Limerick Generating Station, Units 1 & 2
Facility Operating License Nos. NPF-39 and NPF-85
NRC Docket Nos. 50-352 and 50-353

Subject: Request for License Amendments Related to Application of Alternative Source Term

RECENTLY IRRADIATED FUEL

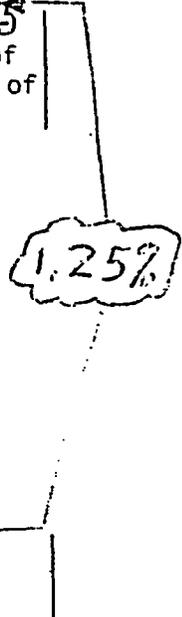
1. With one standby gas treatment subsystem inoperable, restore the inoperable subsystem to OPERABLE status within 7 days, or ~~suspend handling of irradiated fuel~~ in the secondary containment, ~~CORE ALTERATIONS~~, and operations with a potential for draining the reactor vessel. The provisions of Specification 3.0.3 are not applicable.
2. With both standby gas treatment subsystems inoperable, suspend handling of ~~irradiated fuel~~ in the secondary containment, ~~CORE ALTERATIONS~~, and operations with a potential for draining the reactor vessel. The provisions of Specification 3.0.3 are not applicable.

~~*Required when (1) irradiated fuel is being handled in the refueling area, secondary containment, or (2) during CORE ALTERATIONS, or (3) during operations with a potential for draining the reactor vessel with the vessel head removed and fuel in the vessel.~~
